ADDENDUM NUMBER 02

**ARPA- CAMPGROUND EXPANSION PROJECTS
A FEDERAL AID PROJECT**

PAWTUCKAWAY STATE PARK

DIVISION OF PUBLIC WORKS PROJECT NUMBER 81205R

1 BUILDING SECTION 1
Scale: 1/4" = 1'-0"

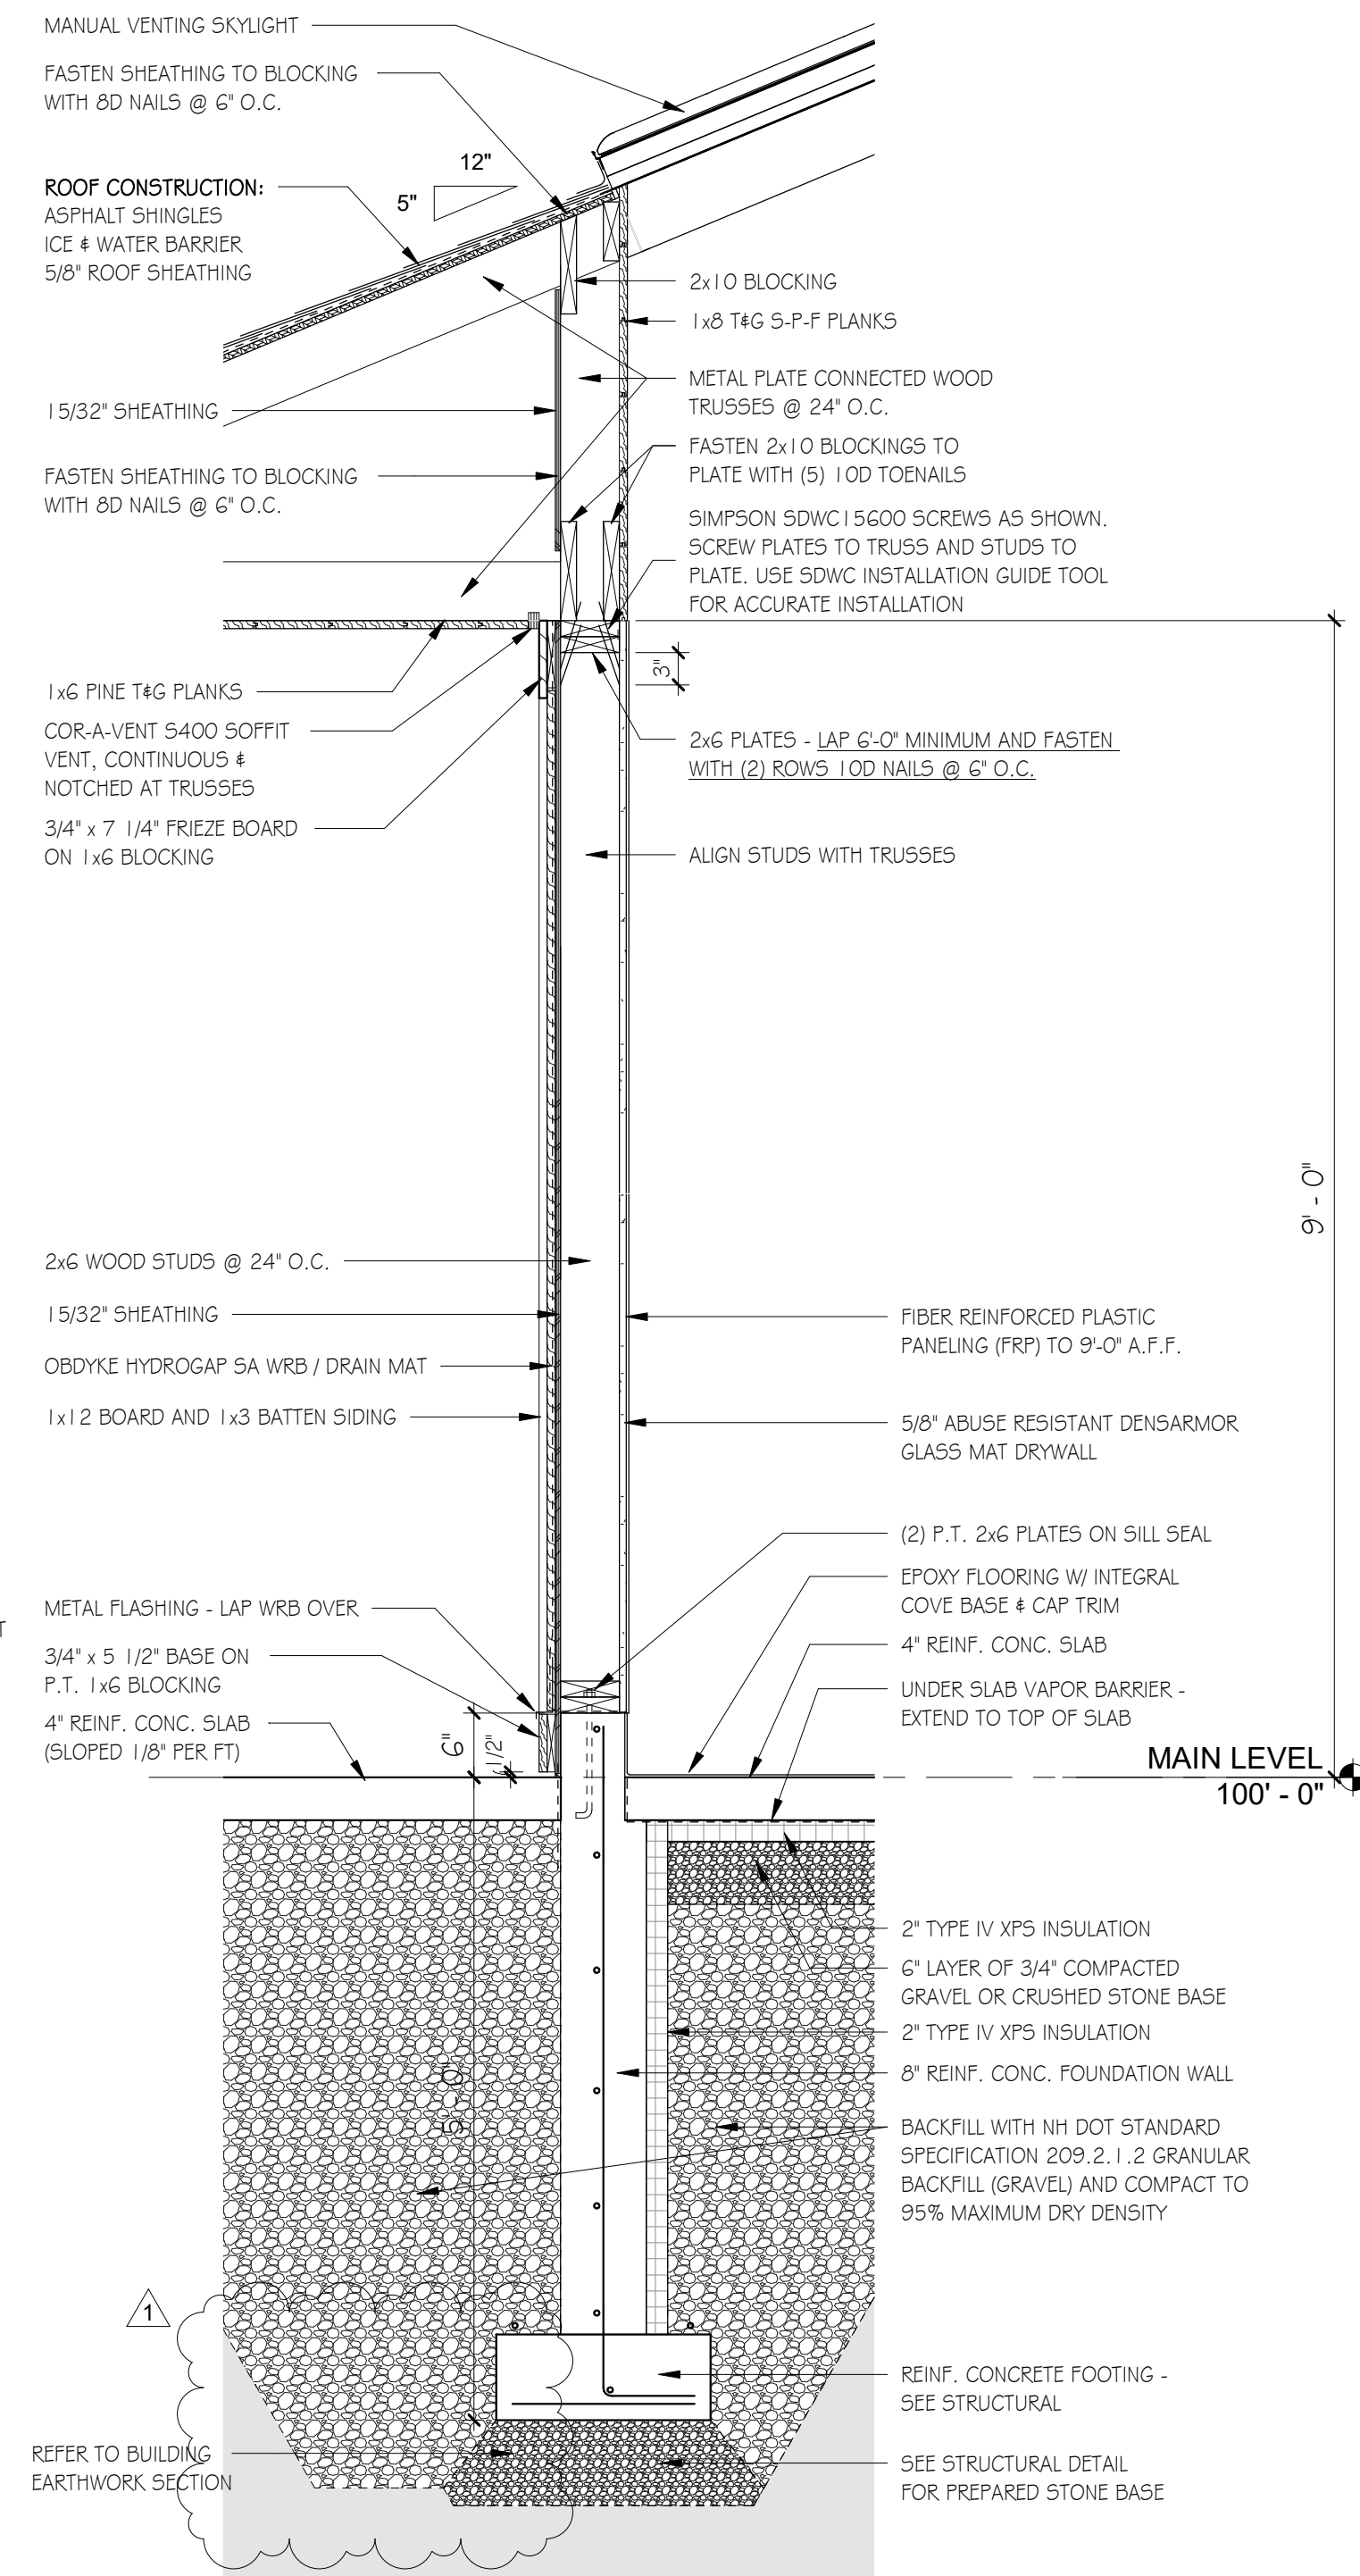
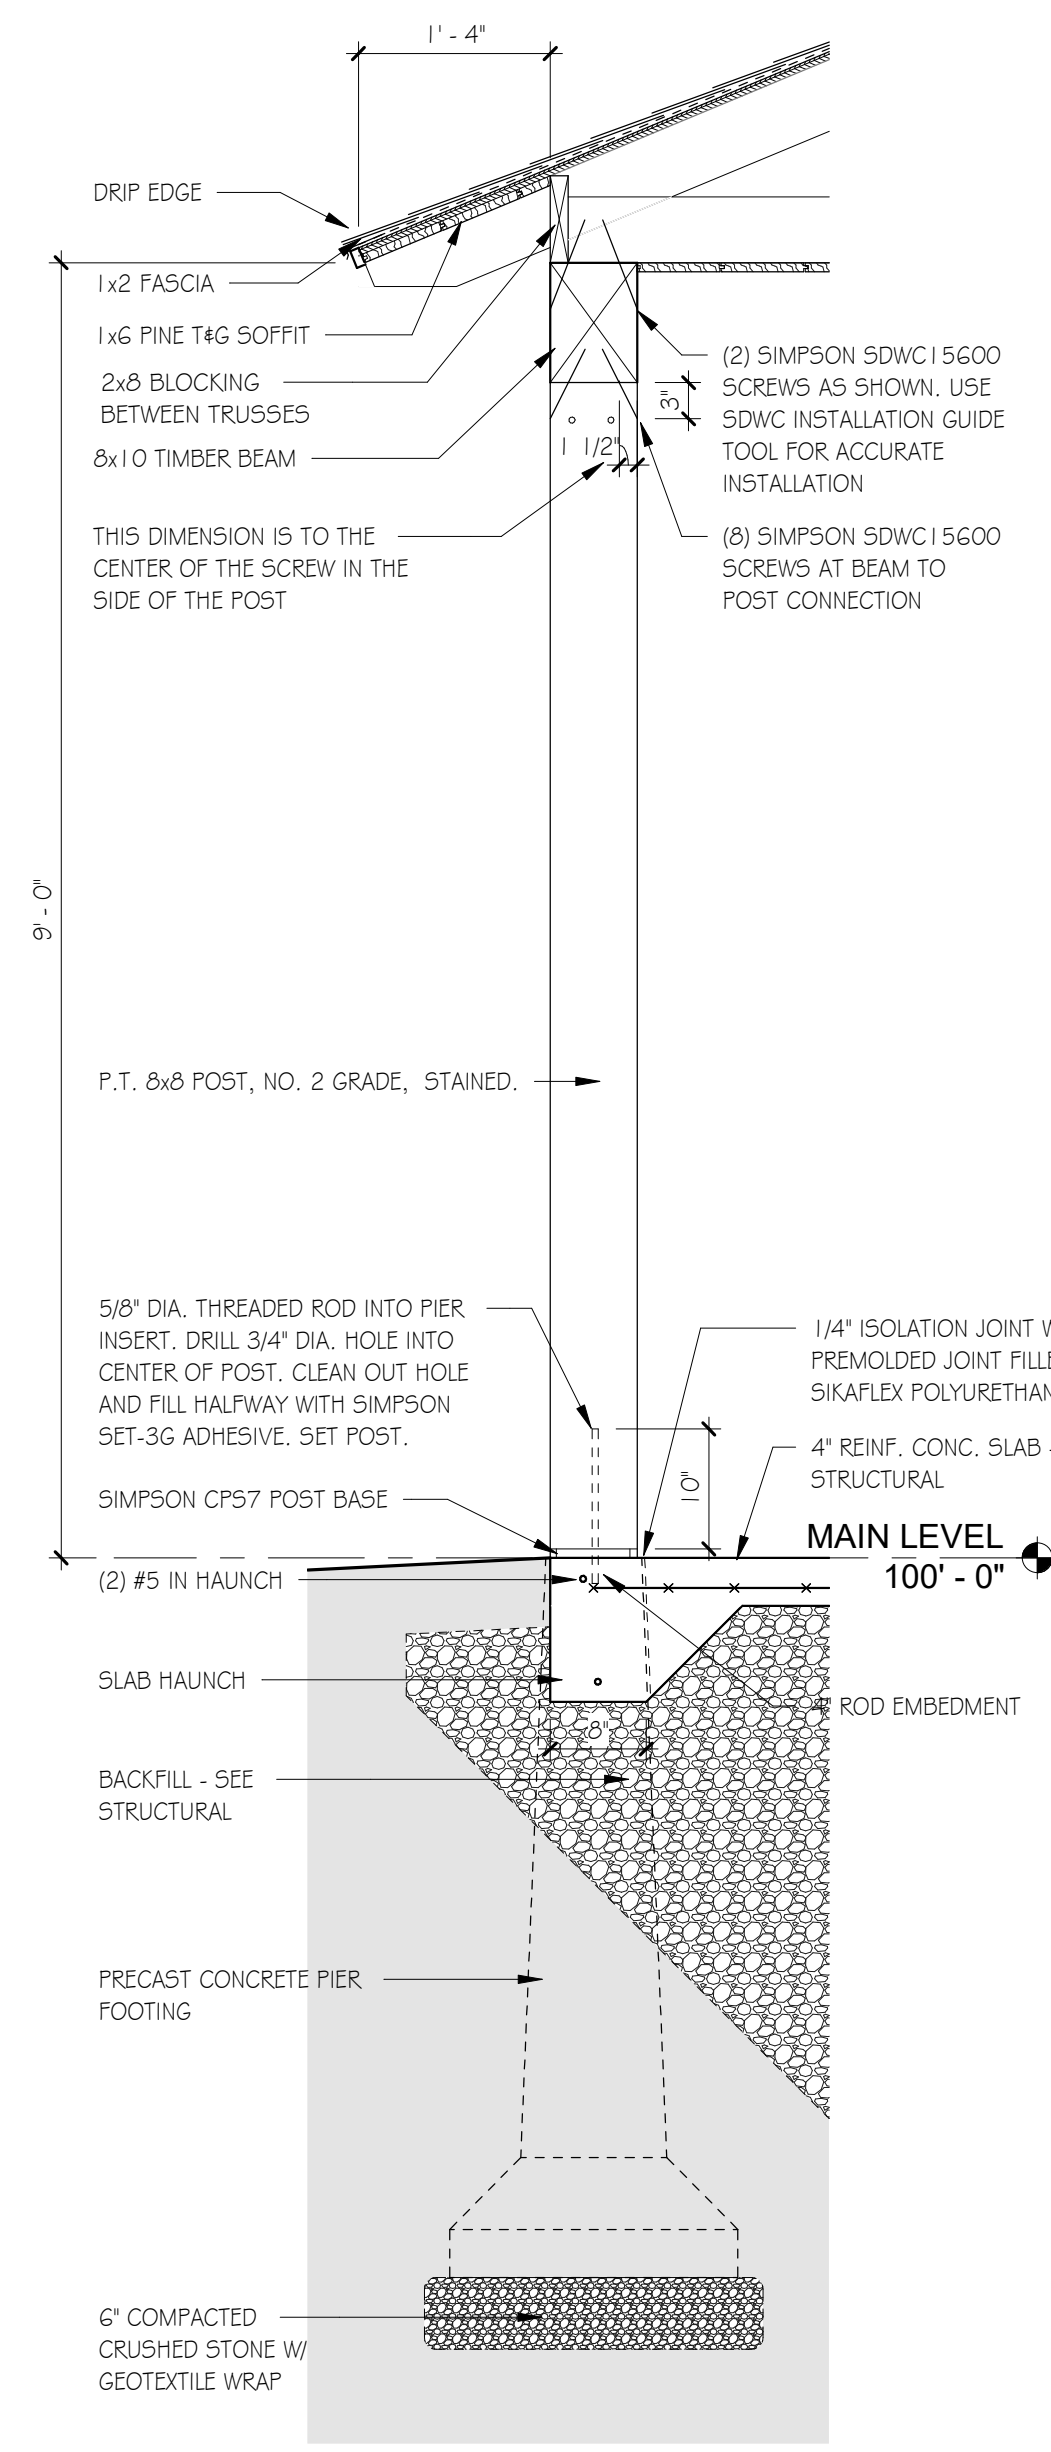
8. Deleted foundation drain.

Response: *Foundation underdrains are not required. See revised sheets A3.01 and S1.01.*
40. Question: Specification 310519.16 Geomembrane Liners. Where is this specification applicable? I do not see any areas noted for geomembrane liners.
